Detailed response to Architectus' request for additional information (RFI 2 May 2021) DA/836/2020 Liverpool Civic Place

Proposed Mixed-Use Development Known as Liverpool Civic Place – 52 Scott Street, Liverpool

Liverpool Civic Place - DA RFI 2

6c Planting to Augusta Cullen Plaza

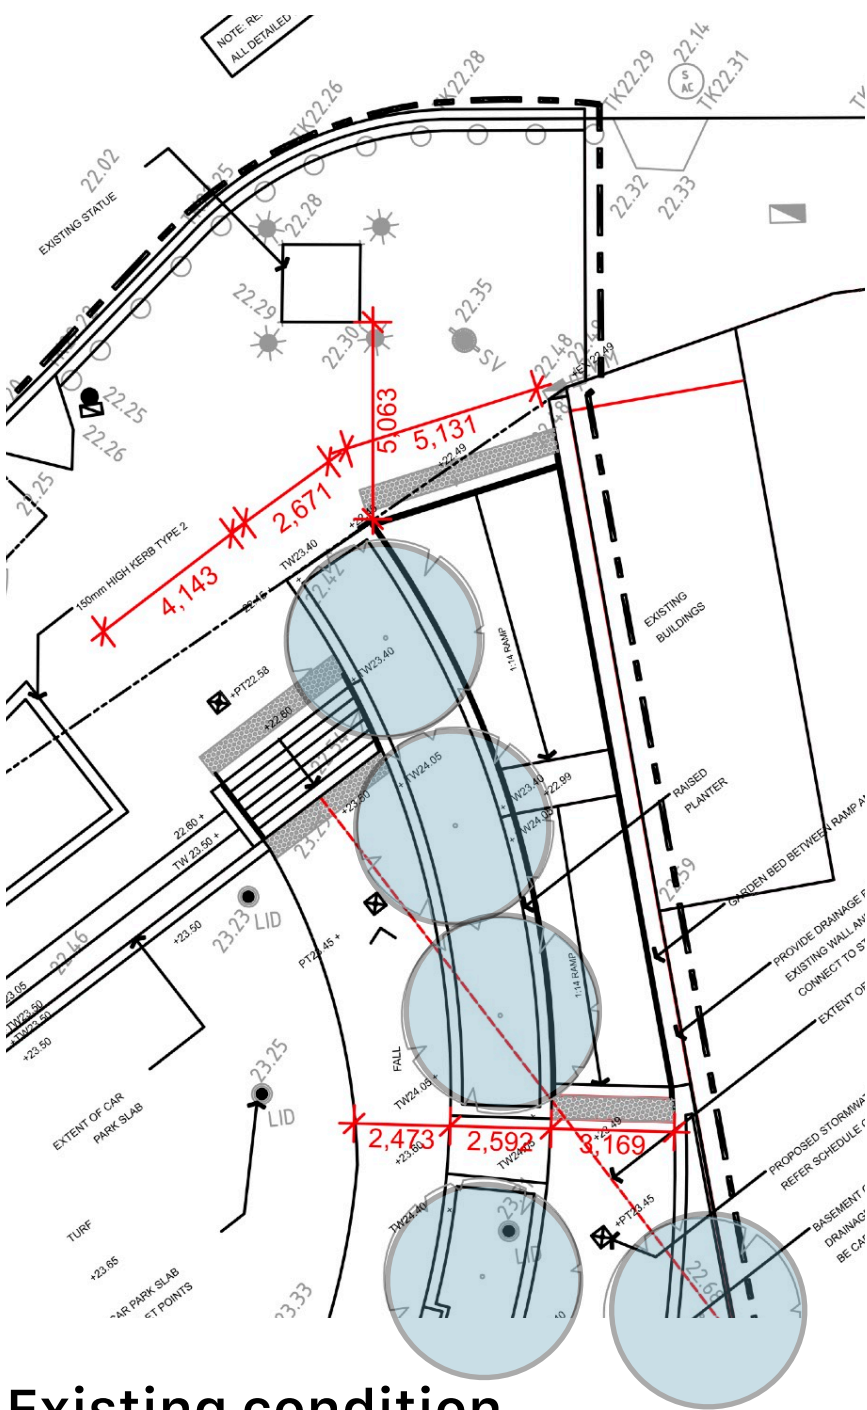
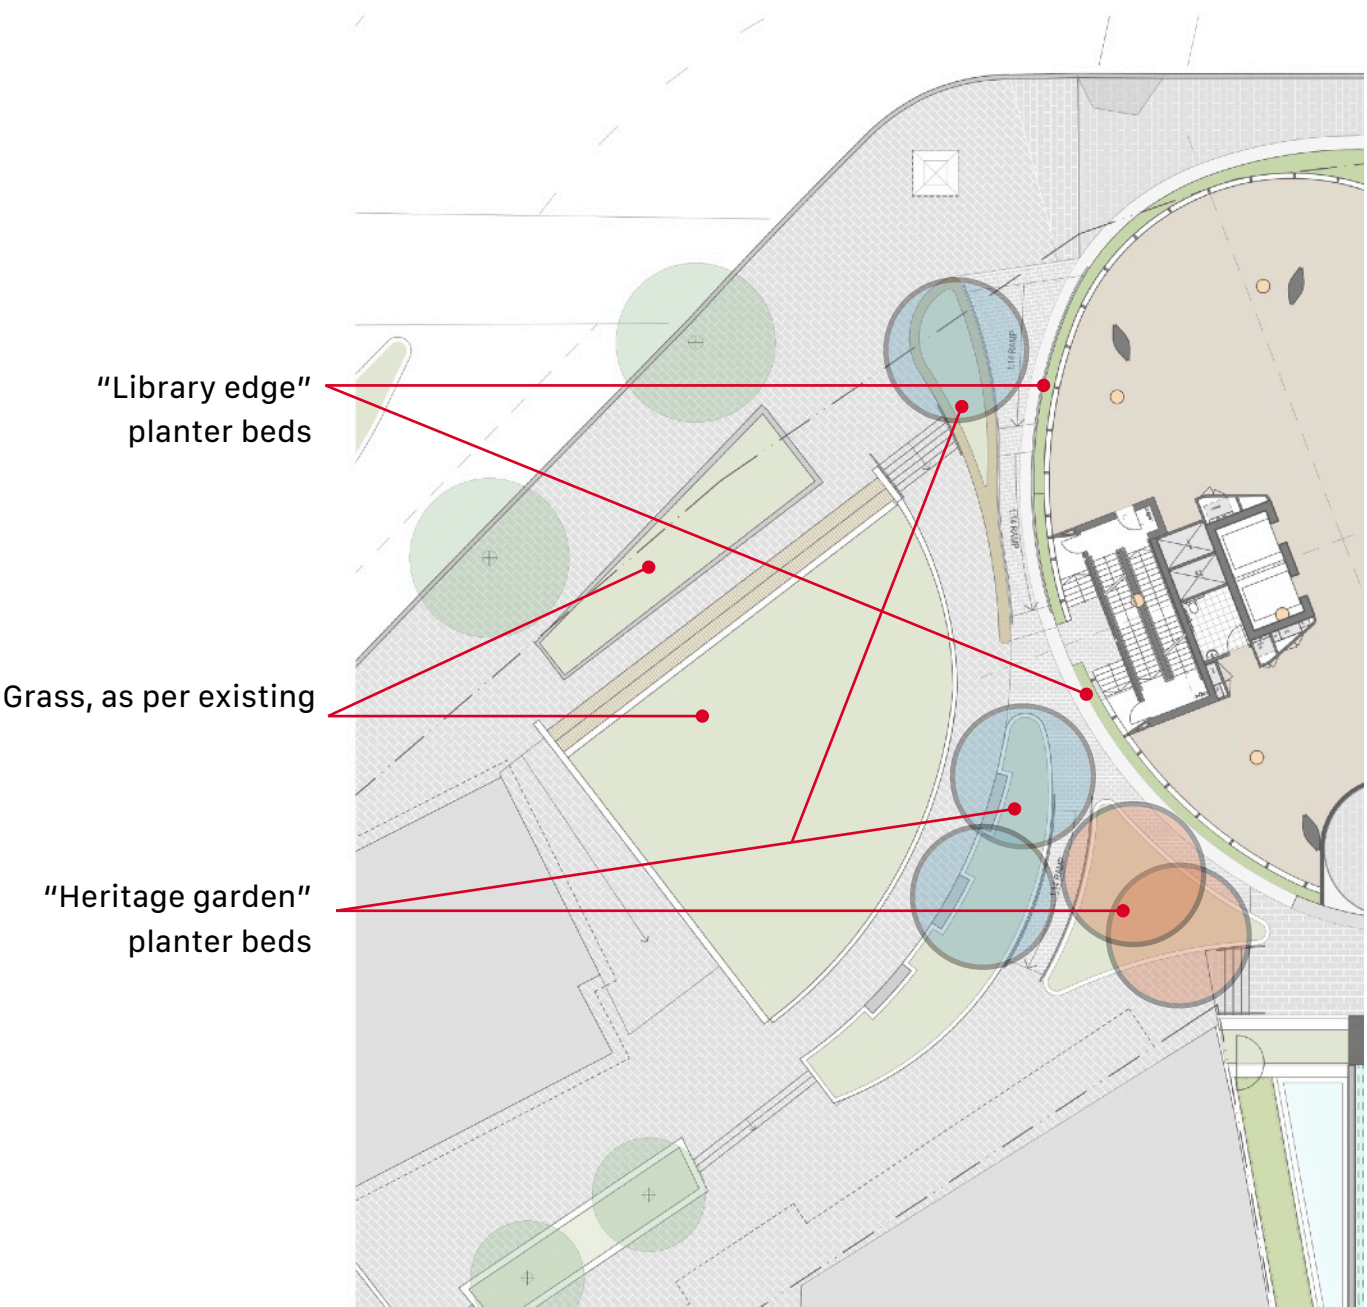
Owner at 300 Macquarie Street, wish to seek some further clarification and have input into the nature of the planting which will be provided within Augusta Cullen Plaza prior to its implementation. We are currently having difficulty to determine exactly what species are being provided. Clearly, the outcomes as discussed regarding landscaping have been entered into as part of the Deed and needs to be part of this application.

Trees The existing condition provides 5x deciduous Chinese Tallowood trees along the planter between the public stair and public ramp. Our proposal matches the identical number of trees, preserving 3 Chinese Tallowoods to the planters between the revised ramp and stair, with 2 evergreen Tulipwoods by the link between the library and civic entry for wind mitigation.

Planter beds accommodate a mix of low shrubs, as per the species palette adjacent. The “Heritage garden” species palette includes a mix of spill over planting to soften the existing planter walls, flowering colours to match both the library and the school of arts brick. The “Library edge” planters surrounding the library proposes fine dull-green native grasses and white flowering plants.

5.1.7 Condition to 300 Macquarie Street

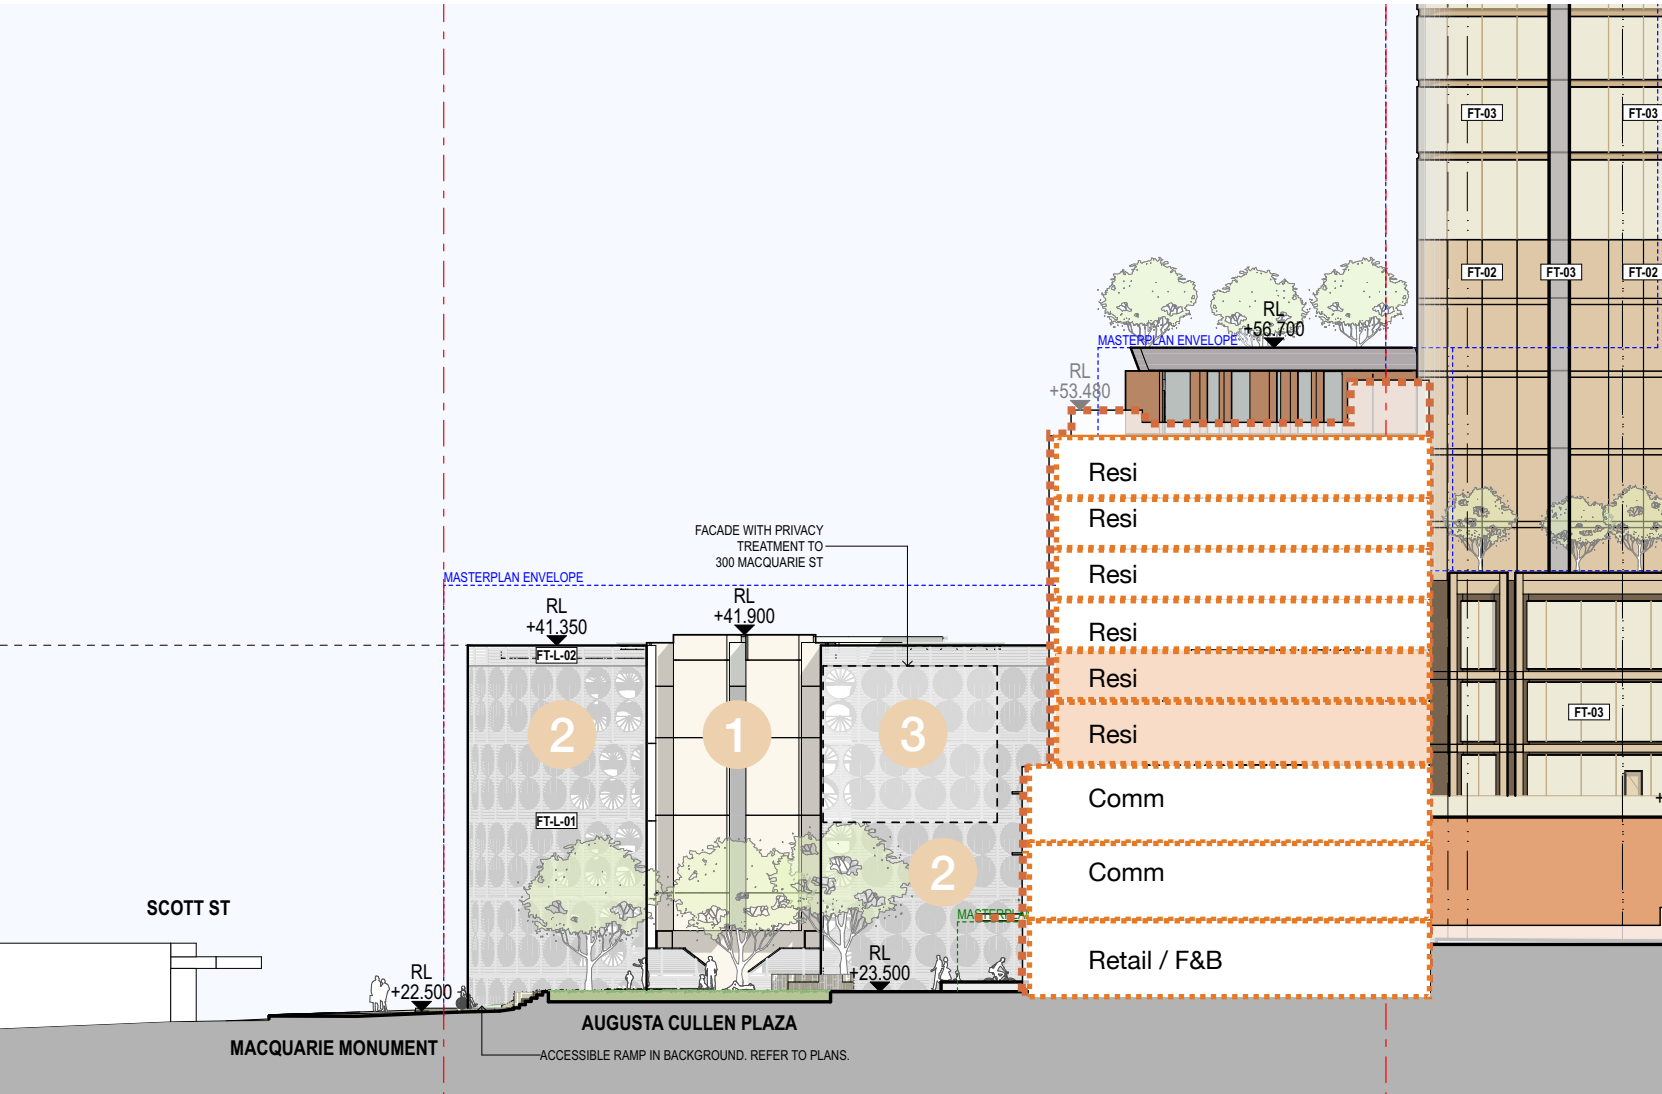
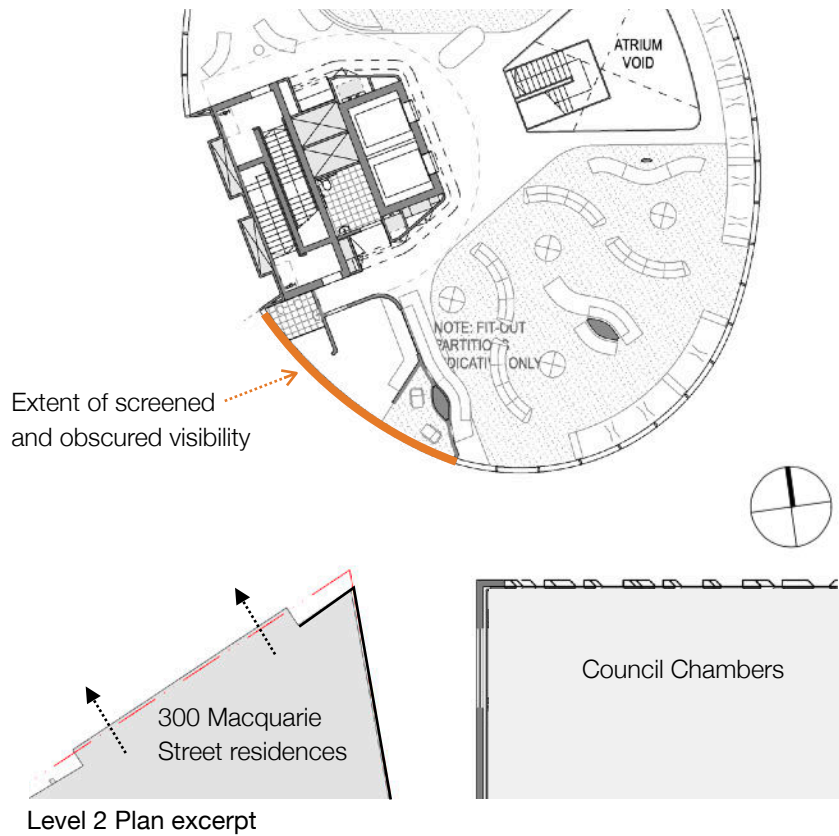
Item Raised	Proponent's Response
<p>6E <i>External glare from the lighting of the Library and whether the proposed screens would mitigate an impact to the residential units in my client's development at 300 Macquarie Street. This is an issue which has been raised continuously and is still unclear whether this issue has been resolved.</i></p>	<p>FJMT has sought to minimise light spill and privacy impacts to the residential apartments within the 300 Macquarie Street building through the development of the library façade design and core location. In particular, privacy to these apartments was assessed and considered as part of the Concept DA and detailed further within Section 5 of the Design Report (refer to Attachment D) that was publicly available during the exhibition of this DA.</p> <p>As detailed as Attachment D, careful consideration has been given to the potential impacts resulting from this building and its proximity to the north-easternmost apartments of the building at 300 Macquarie Street, with a number of design responses adopted to ameliorate any potential privacy and light spill impacts: These include the following design responses:</p> <ul style="list-style-type: none"> • solid façade to the fire stair. • treatment to façade on level 2 and 3 in the area closest to 300 Macquarie Street building with fixed (closed) radial blinds (refer to Attachment D). • typical library façade is glazed with heavily integrated shading and adjustable blinds. The program of the blinds is subject to proposed operation and use of the building under a separate development consent. <p>As mentioned above, the fitout and use of the library building will be subject to a separate development consent. This will be required to detail operational measures and further detailed design features to mitigate light spill, i.e extent that the lights will on and the respective intensity of illumination. We anticipate that the Development Application for the fit out and use of the public library building will be notified in accordance with Council's requirements, enabling the owner of 300 Macquarie Street an opportunity to review the proposed detailed design and operational plan of management.</p>

The proposal has considered the need to locate heavily used areas within the library away from the existing multi-use building adjacent. The facade treatment on the upper two levels also requires fixed screening to obscure vision from the library interiors and preserve privacy to the residential neighbours.

- 1. Solid facade to fire stair.
- 2. Typical Library Facade. Refer to previous section.
- 3. Privacy treatment to facade on level 2 and 3 in area denoted, to match surrounding facade but with fixed (closed) radial blinds and fritted or obscure glazing.
